AIR HANDLING SYSTEM RETRO-COMMISSIONING TRENDING ANALYSIS

AIR HANDLING UNIT TRENDS

RETRO-CX MEASURE #7

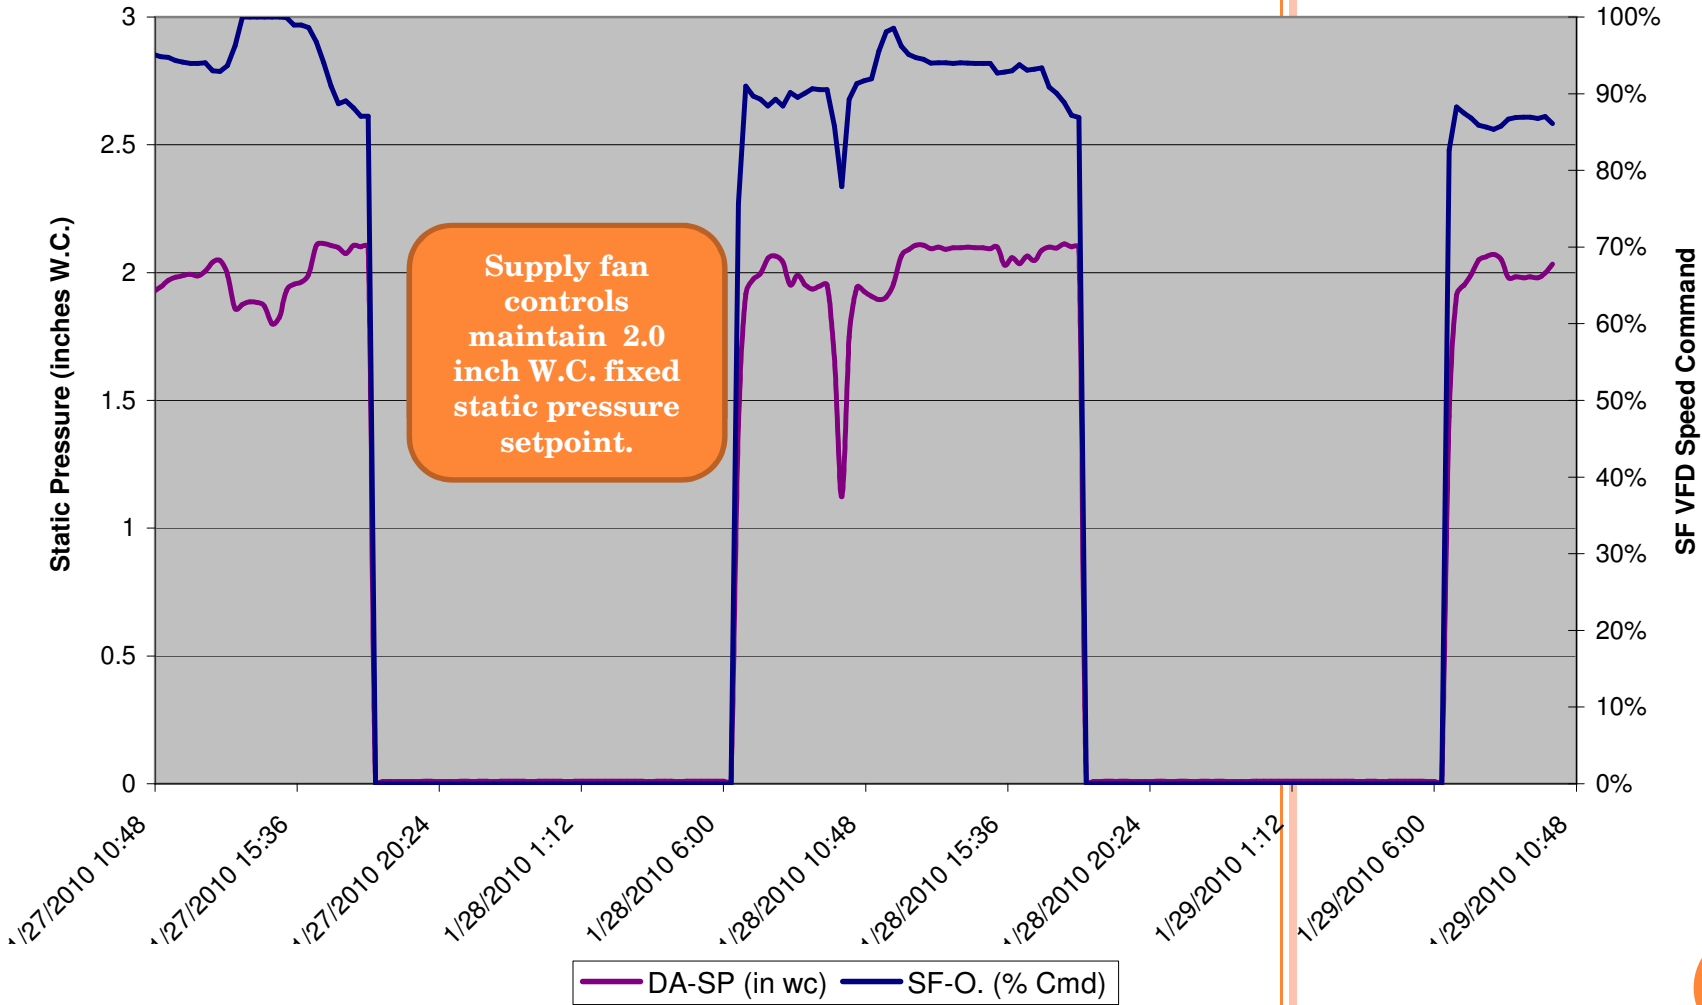
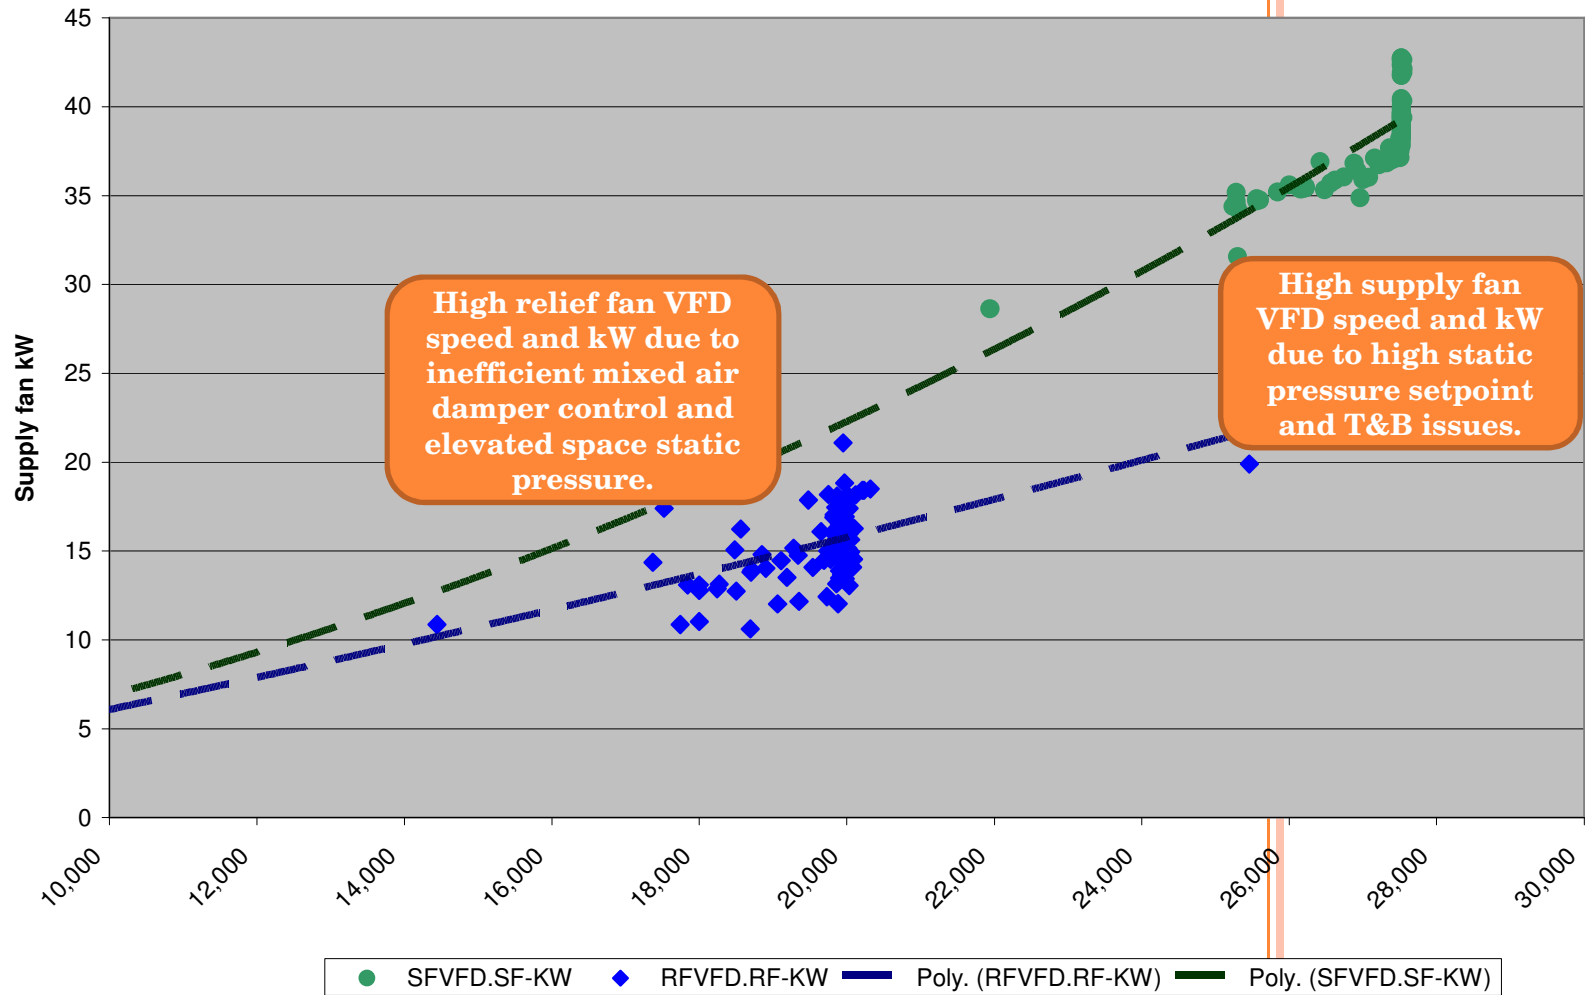
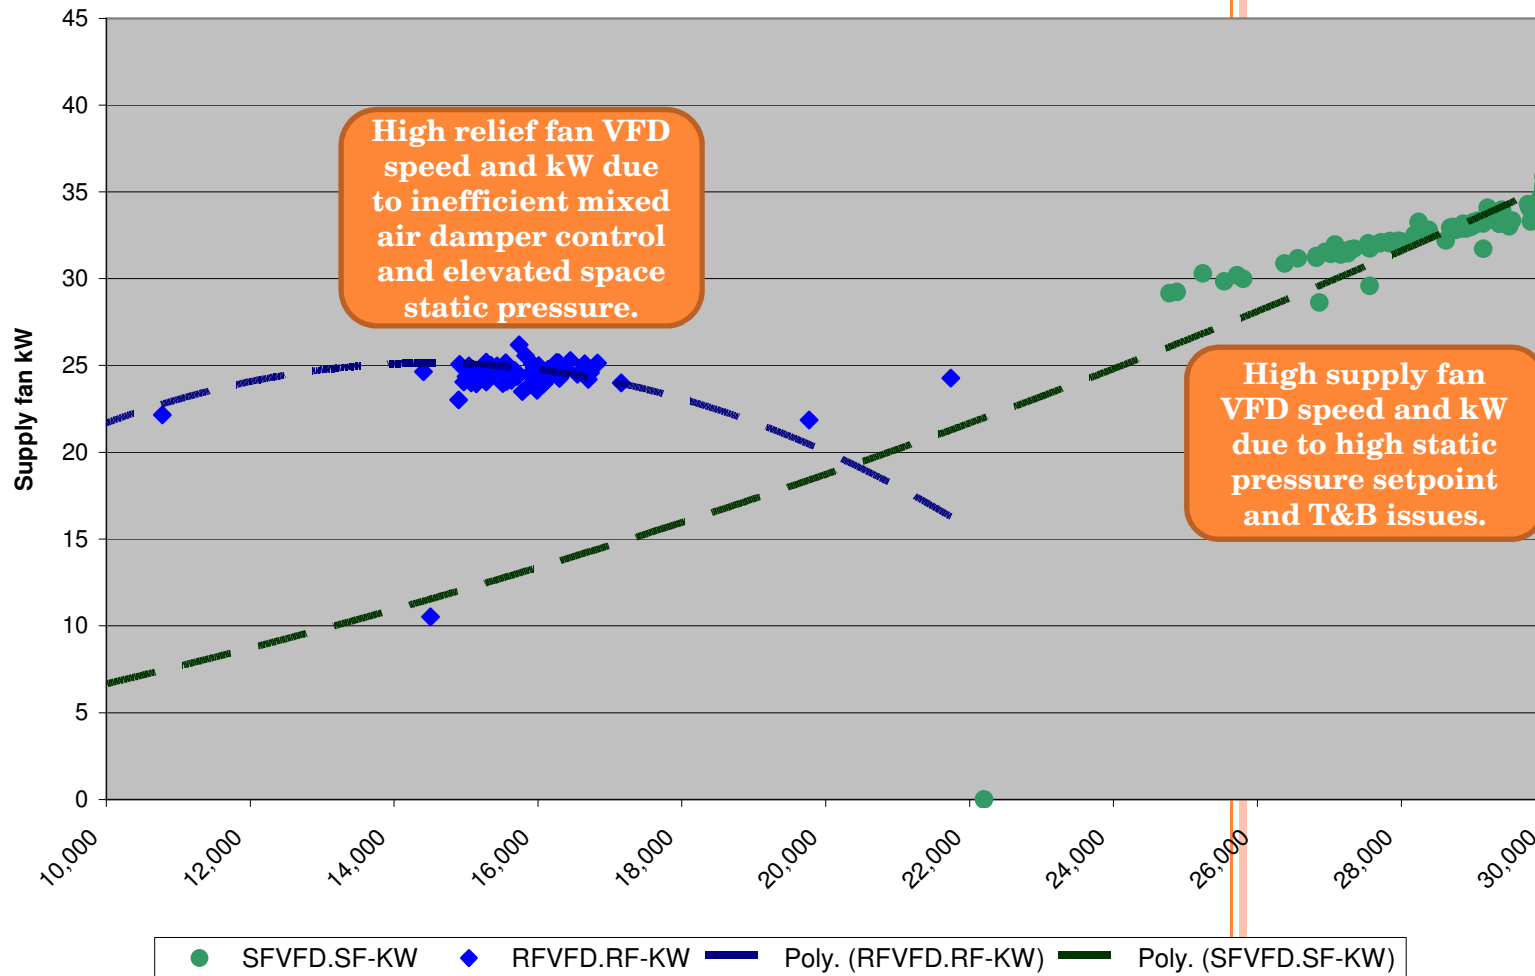
- During cold outside air temperatures VFD speeds on several air handling units operate in the range of 90% to 100%.
- Typical VAV operation is expected to modulate to a minimum position during moderate and heating modes of operation with reduced supply air fan speed and power consumption.
- Frequent period of supply fan speed greater than 90% and for a period at 100% speed are observed.
- High motor power consumption at higher supply and return fan operating speeds/ flow rates. The return fan is controlled to maintain a fixed airflow differential from the supply fan.
- Any means implemented to reduce supply fan speeds and motor usage will have a correlating reduction in return fan speeds and power usage.

- Have a T&B technician review the set-up and establish an appropriate static pressure setpoint.
- Verify sensor locations and move down to 2/3 down longest duct and relocate, if necessary.
- Implement supply static pressure reset function based on zone VAV conditions.
- Balancing system air flow requirements to match the zone level airflow requirements should be the objective of an efficient air delivery system. Static pressure reset will help facilitate this objective.

RETRO-CX MEASURE #8

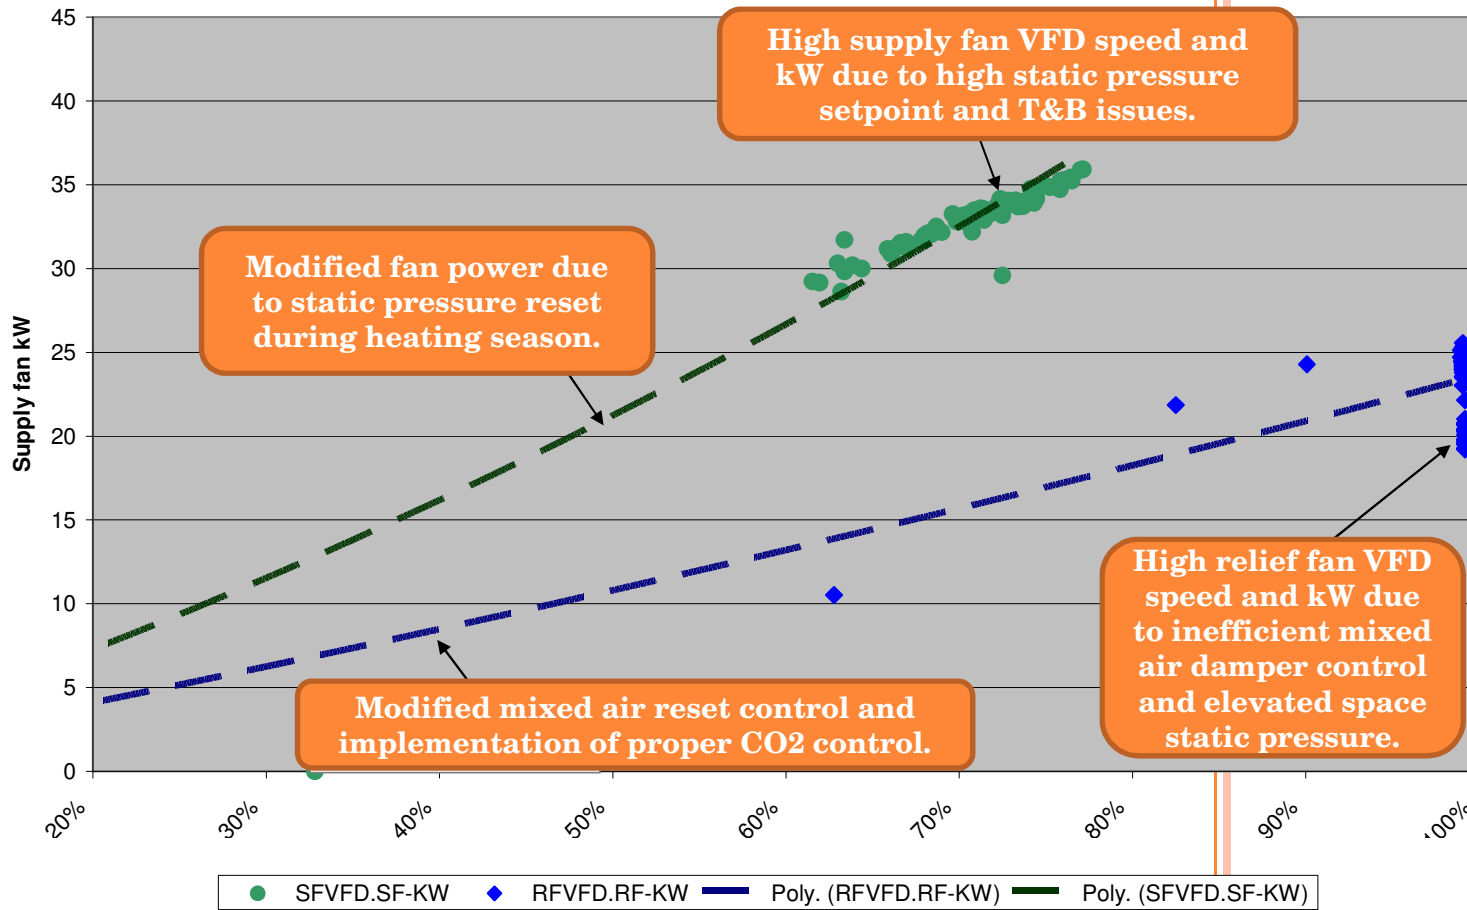
- Supply fan airflow for AHU-3W was measuring 29,980 cfm to maintain 2.0 inches.
- Fixed offset value is -6740 cfm establishing a return airflow setpoint of 23240 cfm.
- Actual return fan airflow at the DDC was measuring 10,870 cfm (12,370 cfm differential).
- Upper Figure shows the operating characteristic for the supply and return fan with supply fan operating in the area of 70% speed and return fan operating at 100% speed.
- Lower Figure shows the fan kW versus CFM. The capacity of the return fan is limited to provide any additional airflow to maintain the required offset between the supply and return fan.

- The issues observed with airflows may have to do with the balance and setup of the fan(s) and/or sheave settings between the fan and the motor.
- In addition, to the balancing requirements associated with RCX #2, it would be of value to rebalance the air handling units along with the sequencing changes.
